Product Change Notification

TRIMPOT® TRIMMING POTENTIOMETERS

Bourns® Trimpot® Product Line Announces Product Change for Model 3314S

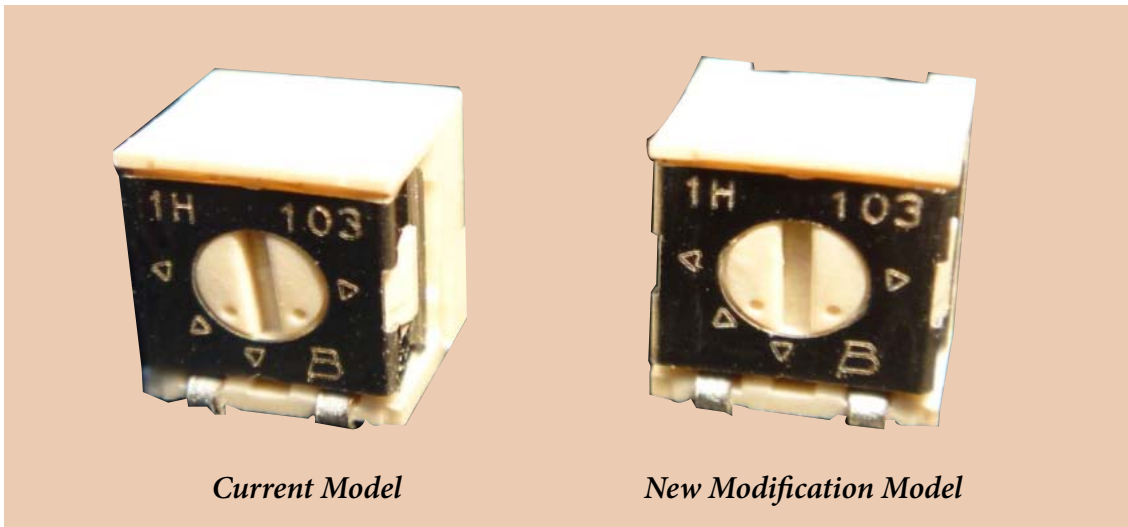
Bourns® Trimpot® Product Line announces a new modification to [Model 3314S](#). This form modification will be used to facilitate packaging orientation and simplify customers' assembly direction.

The modification conversion will take place October, 2011. The effective date code will read **1P**.
